ITB # 26-408 Hampstead Library Construction Services

Addendum 1

November 24, 2025

Photo 2

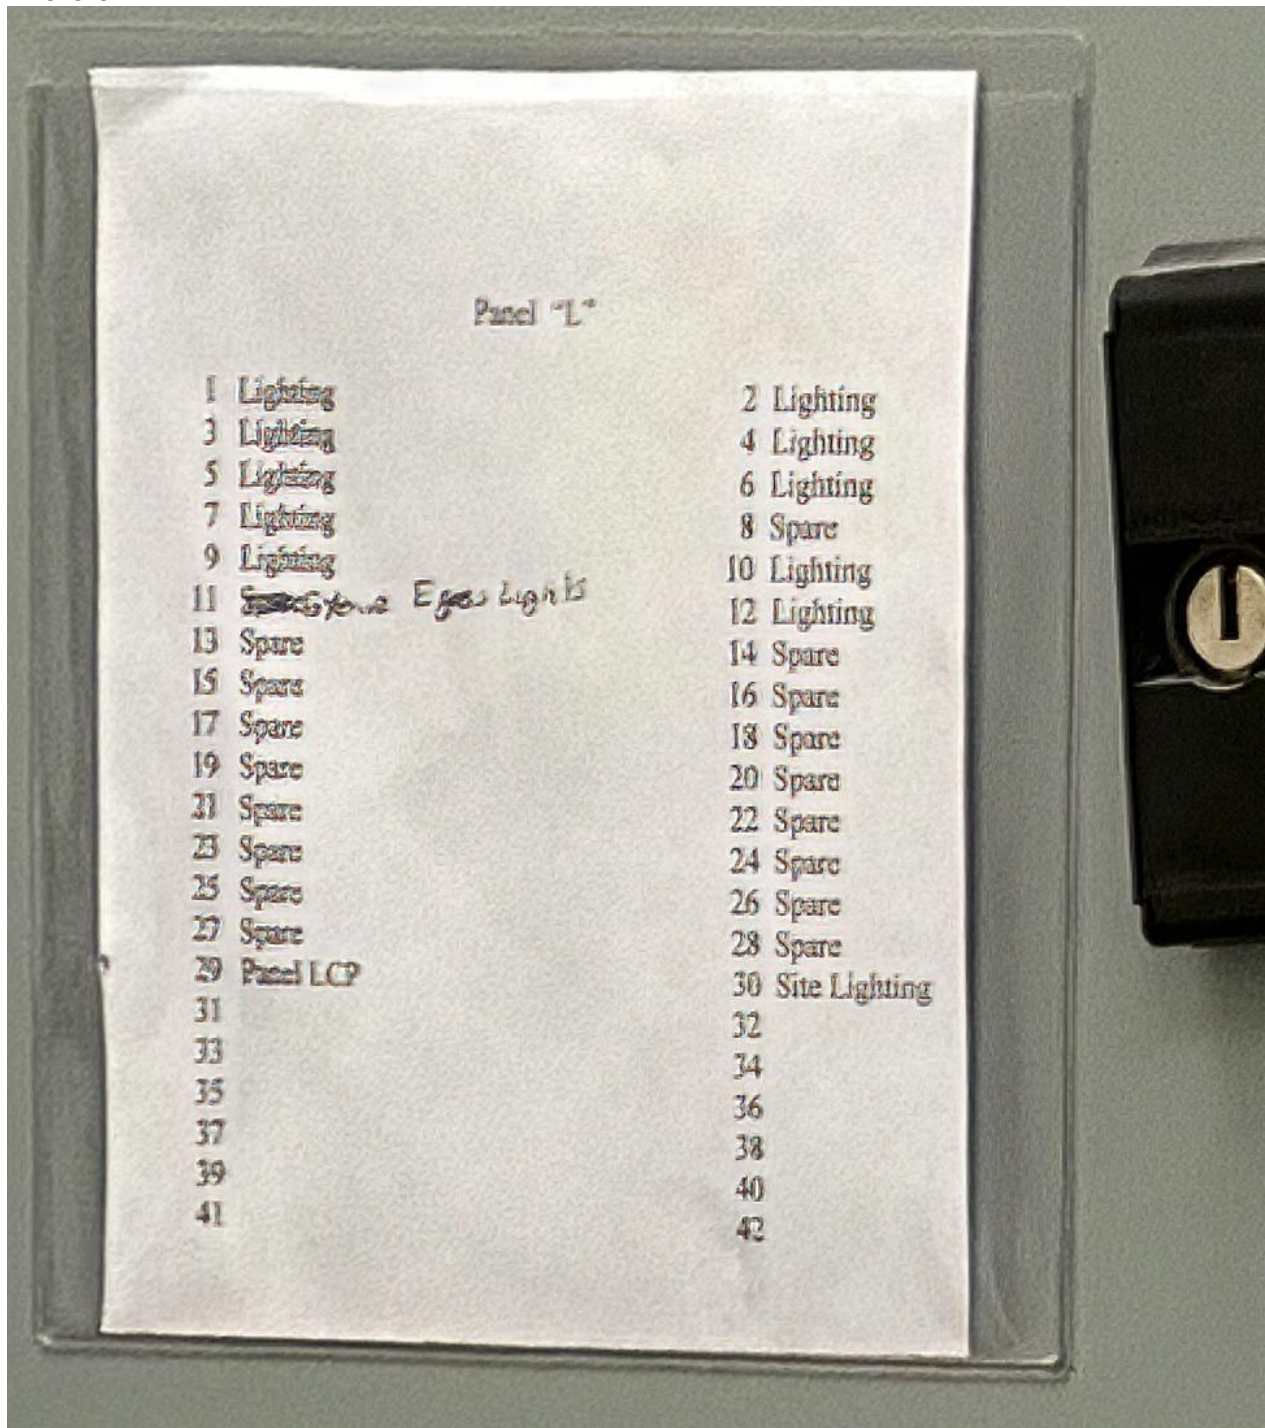
1. The domestic water line and fire line routes shown on sheet U5.1 Site Utility are diagrammatic. The plumber is to set the domestic water and fire piping locations in the riser room and stub out of the building, and the site contractor is to tie into those locations.
2. The waste line route for Exterior Sink SK-4 is to be coordinated in the field to avoid conflict with the fabricated engineered canopy footings.
3. Photos of the existing electrical panel at the Pender County Hampstead Annex are included in this Addendum – See Photos 1, 2, & 3 below.

- C. Can the electrical panel in the Pender County Hampstead Annex be seen during bidding?
 - a. Photos of the existing electrical panel will be included in Addendum 1.
